City of Portland
Development Review Application
Planning Division Transmittal Form

Application Number: 2013-056 **Application Date:** 02/26/2013
CBL: 316 A00500B **Application Type:** Level II Site Plan
Project Name: Parking Lot Expansion
Address: 741 Warren Avenue
Project Description: Parking lot that will create approx. 13,207 sq. ft. of impervious area and 17,078 sq. ft. of landscaped area.
Zoning: IM

Project Name: **Parking Lot Expansion**
Project ID: 2013-056
Address: 741 Warren Avenue CBL: 316-A-500B
Applicant: Downeast Veterinary Emergency Clinic
Planner: Jean Fraser

TO: Jean Fraser, Planner
FROM: David Senus, P.E.
DATE: August 16, 2013
RE: 741 Warren Avenue Parking Lot Expansion, Level II Site Plan Application

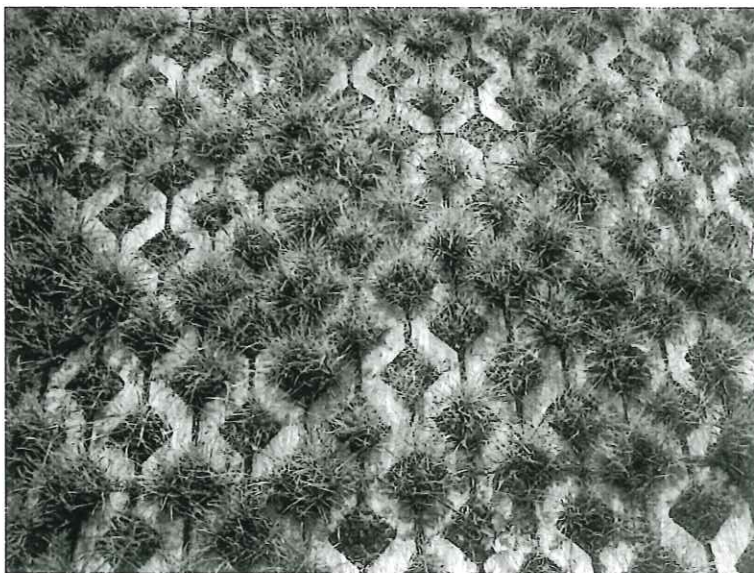
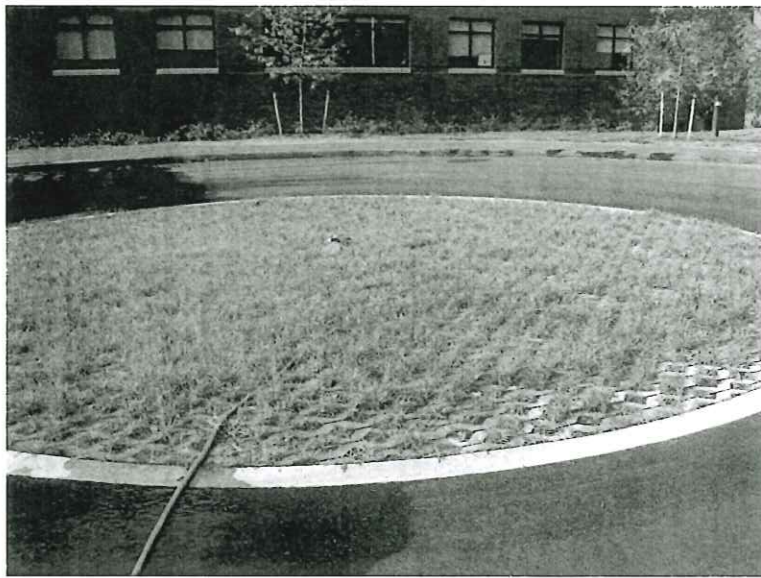
b) Parking Lot trees - Additional shade trees are recommended for the new parking lot area. Trees would be planted along the South / Southwest edges. I would be willing to work with the applicant to determine the location, species and number of trees. Snow storage and circulation would be factored into the design.

c) Disturbed area re-vegetation / tree replacement - It would be recommended to contour the disturbed areas in a natural land form shape vs sharp or straight lines, as possible. Reseeding the disturbed areas with field / conservation mix would be preferred vs turf grass. Replanting trees / shrubs to mimic the existing tree cover is also recommended. The trees could be a mix of native hardwoods and conifers 3-4' / 4-5' with similar spacing as the existing trees. The planting would not need to be extensive but could help reestablish native plants before invasive plants take hold.

d) Turf block paving - Concept wise the idea of creating impervious paving for the parking lot is desirable, having 'turf blocks' or other paving, other than real porous pavement, continue to function effectively in northern climes is a real challenge. Plowing and use of these paved & seeded areas off season when the turf is dormant really degrades the turf growth in the long run. I listed some possible options below and examples of grass block trail nearby.

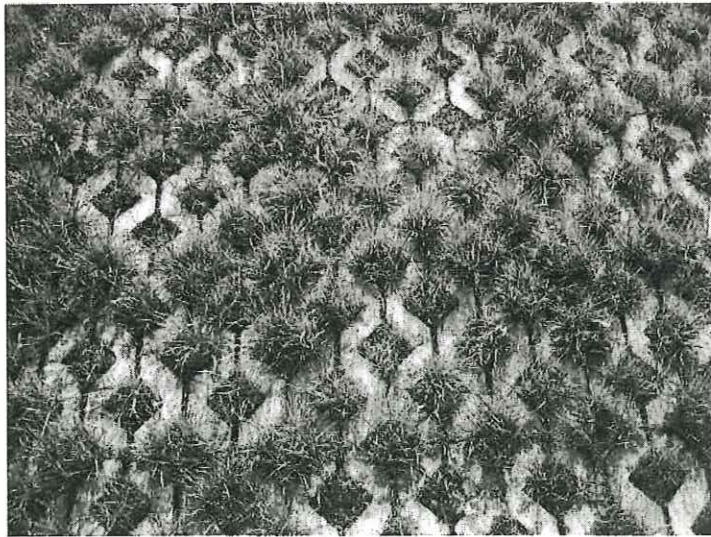
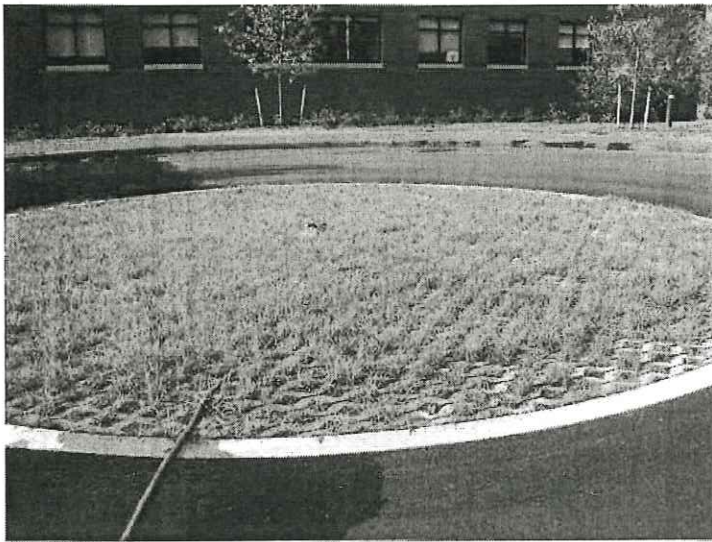
Recommendations in review of the landscape portion of the Emergency Veterinary Clinic on Warren Avenue:

- a) Street-trees - due to the uniqueness of the site location and the proposed impact the planting of 'one' street tree along Warren Avenue would be recommended. The tree would need to tolerate wet conditions so we are recommending one of the following: Tupelo, Red Maple, or Larch. The tree would be planted set-back from the road as to not obscure the way finding to the site and the nearby sign for Hammond Lumber of the businesses nearby.

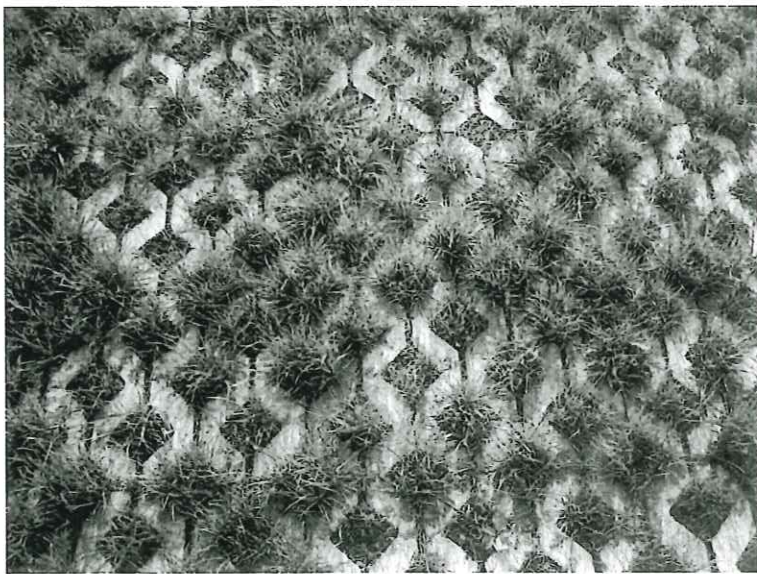
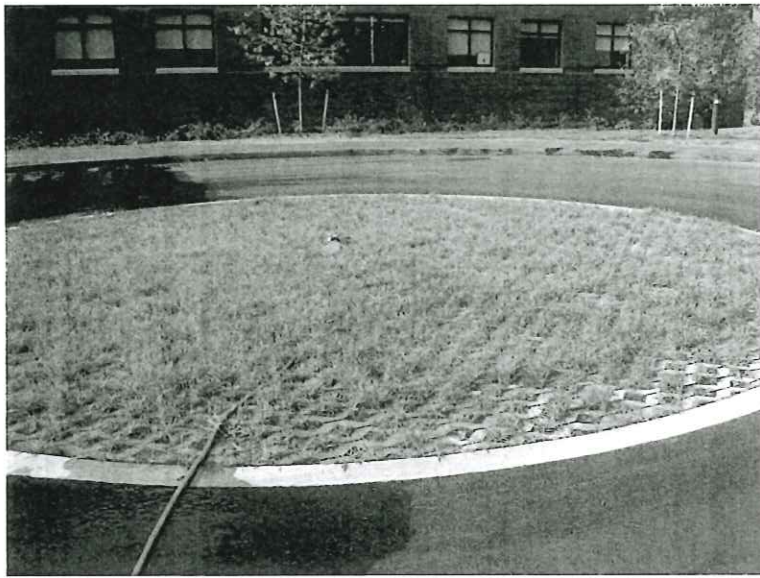
b) Parking Lot trees - Additional shade trees are recommended for the new parking lot area. Trees would be planted along the South / Southwest edges. I would be willing to work with the applicant to determine the location, species and number of trees. Snow storage and circulation would be factored into the design.

c) Disturbed area re-vegetation / tree replacement - It would be recommended to contour the disturbed areas in a natural land form shape vs sharp or straight lines, as possible. Reseeding the disturbed areas with field / conservation mix would be preferred vs turf grass. Replanting trees / shrubs to mimic the existing tree cover is also recommended. The trees could be a mix of native hardwoods and conifers 3-4' / 4-5' with similar spacing as the existing trees. The planting would not need to be extensive but could help reestablish native plants before invasive plants take hold.

d) Turf block paving - Concept wise the idea of creating impervious paving for the parking lot is desirable, having 'turf blocks' or other paving, other than real porous pavement, continue to function effectively in northern climes is a real challenge. Plowing and use of these paved & seeded areas off season when the turf is dormant really degrades the turf growth in the long run. I listed some possible options below and examples of grass block trail nearby.
